In the Matter of)	
FLORIDA POWER AND LIGHT COMPANY)	Docket Nos. 50-250 OLA-2
(Turkey Point Plant, Units 3 & 4))	50-251 OLA-2
)	(SFP Expansion)

STAFF REPLY TO APPEAL BOARD ORDER OF JUNE 27, 1988

Request for Additional Information -
Boraflex Usage at Turkey Point

FIGURE 1

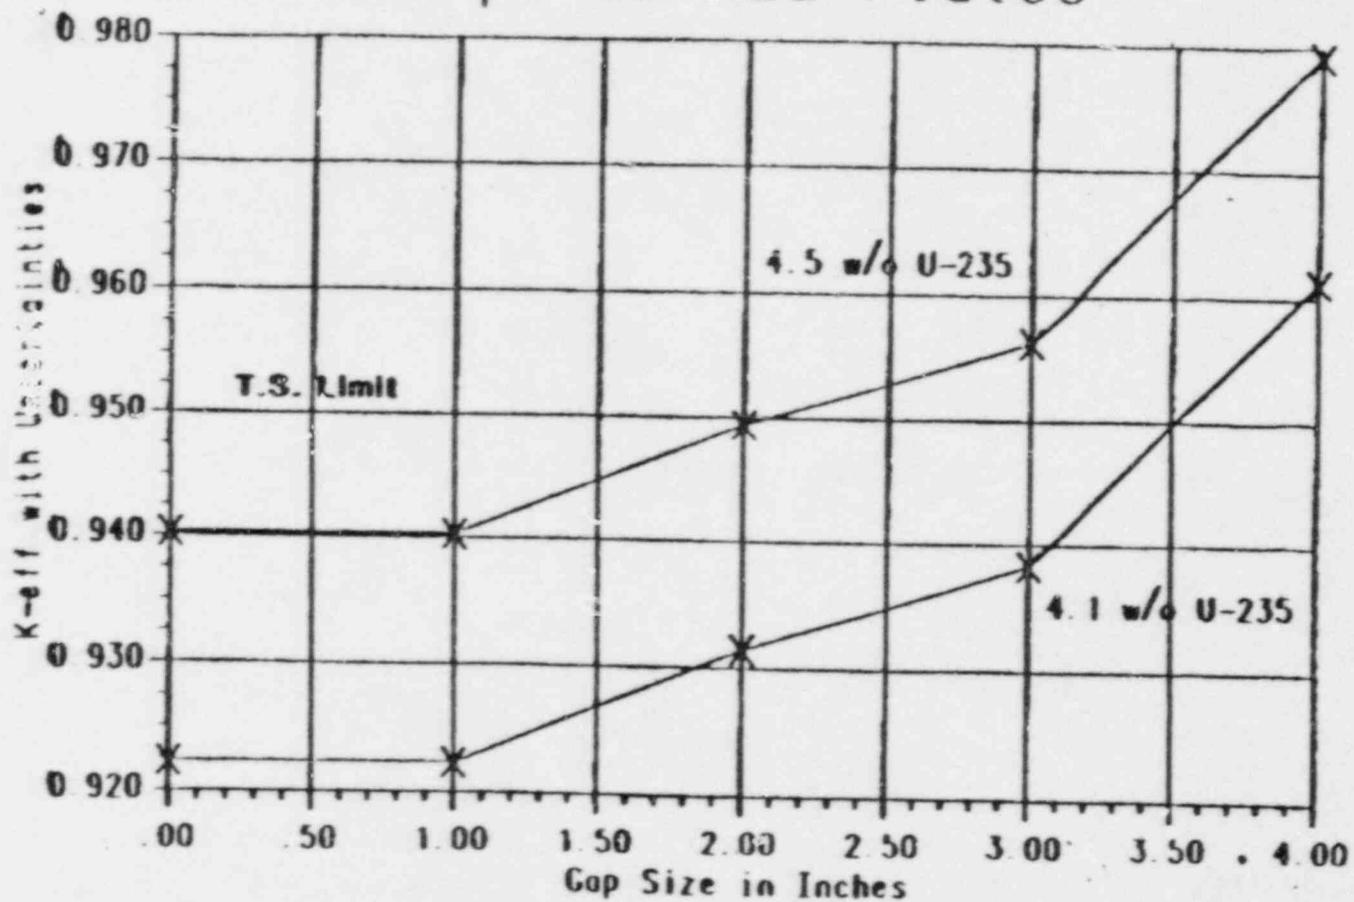
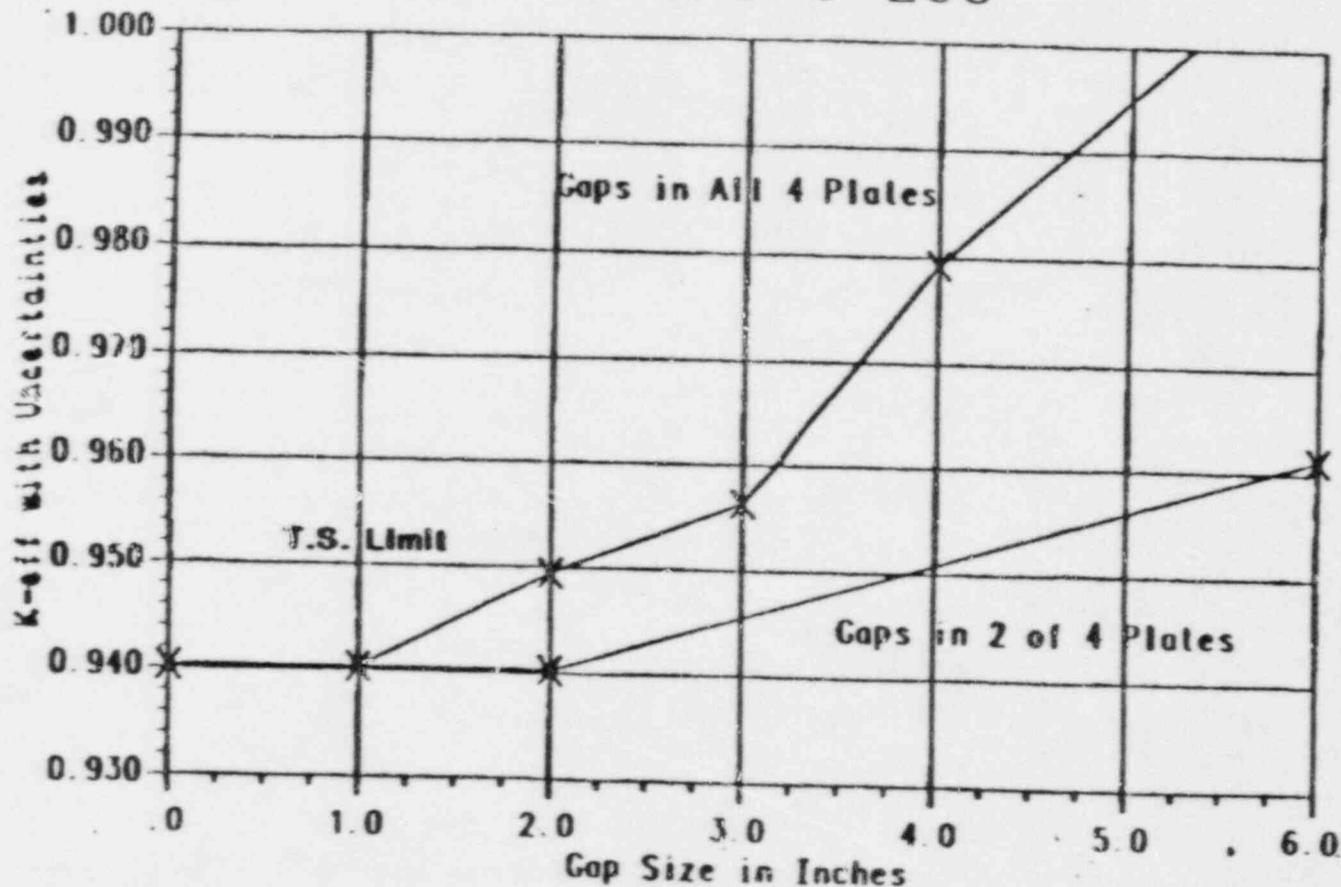
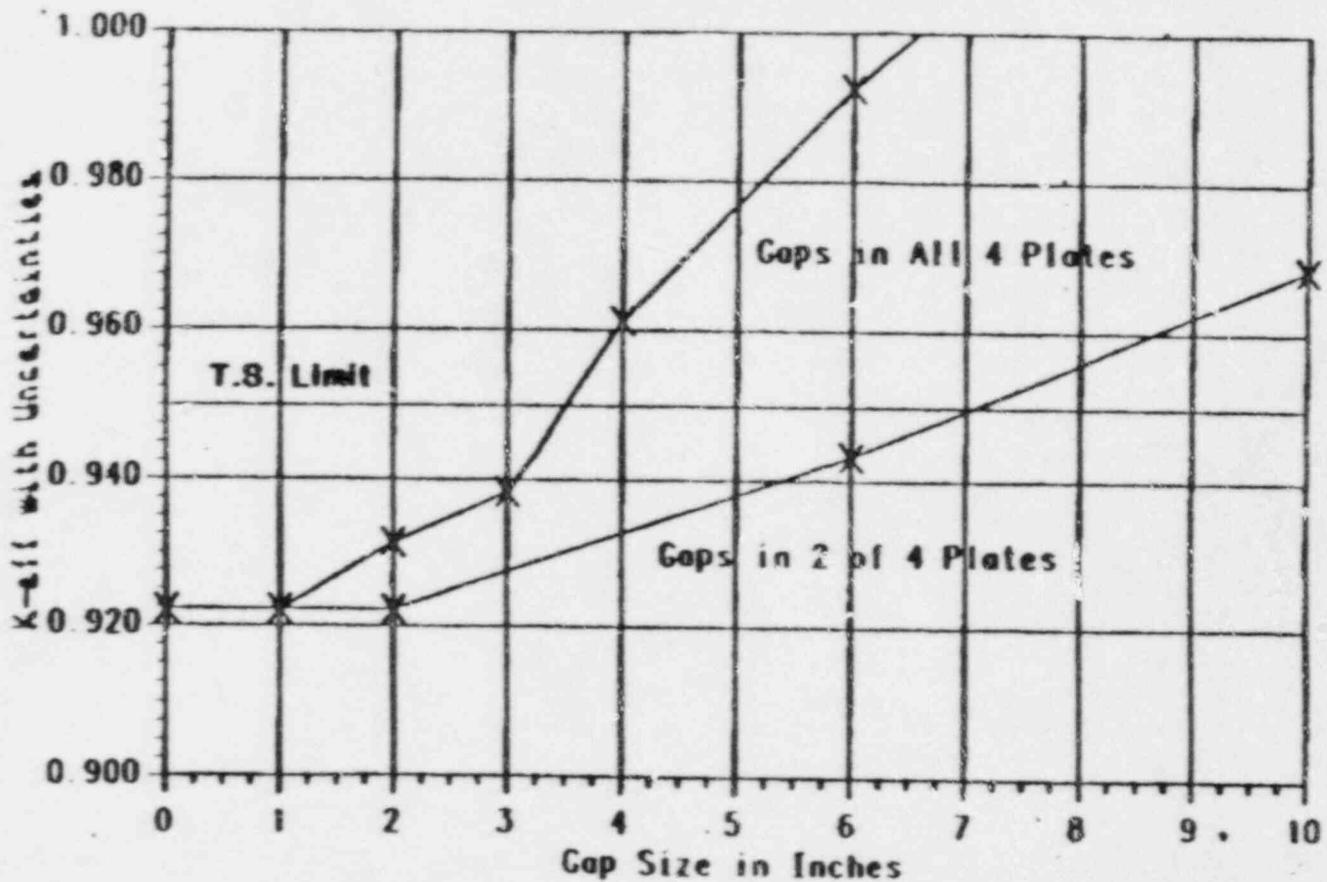
Based on the recent experience pertaining to degradation of Boraflex in spent fuel pools at Quad Cities and Point Beach Nuclear Power Plants, provide justification to demonstrate the continued acceptability of Boraflex for application in the Turkey Point spent fuel pool.

Based on the recent information, provide any changes to the in-service surveillance program for Boraflex neutron absorbing material and describe the frequency of examination and acceptance criteria for continued use. Provide the procedures for testing the Boraflex material and interpretation of test data.

Describe the corrective actions to be taken if degraded Boraflex specimens or absorber is found in the spent fuel pool.

A sensitivity study has been performed to determine whether the Boraflex material at Turkey Point would be acceptable if it develops gaps. As discussed above, tests and the Quad Cities surveillances indicate that 2% shrinkage could occur. If it is conservatively assumed that this shrinkage would cause gaps in the Turkey Point Boraflex, the shrinkage could result in a two or three inch gap. If it is postulated that such gaps would occur in every Boraflex panel at exactly the same location (which is an extremely conservative and unrealistic assumption based on the Quad Cities data), the attached curves show that the Turkey Point spent fuel pool would still maintain the required shutdown margin. This shutdown margin does not account for the 1950 ppm boron in solution which adds an additional 30% Δ k/k shutdown margin.

The KENO calculations and the original criticality analysis assume a maximum U-235 enrichment of 4.5 w/o. The results are presented in Figures 1 and 2.

It was also requested that the same type of data be provided with a maximum U-235 enrichment of 4.1 w/o assumed. The original criticality analysis included a study which showed the sensitivity of rack K_{eff} to fuel enrichment for the Region 1 spent fuel racks. This study was used to determine that the decrease in U-235 enrichment from 4.5 w/o to 4.1 w/o results in a 0.018 ΔK decrease in rack K_{eff} . This small change in fuel enrichment does not significantly effect the reactivity worth of the gaps in the poison plates. The data for the study using the 4.1 w/o fuel was produced by subtracting the 0.018 ΔK from the results of the 4.5 w/o fuel study. The results of this second study are presented in Figures 1 and 3.
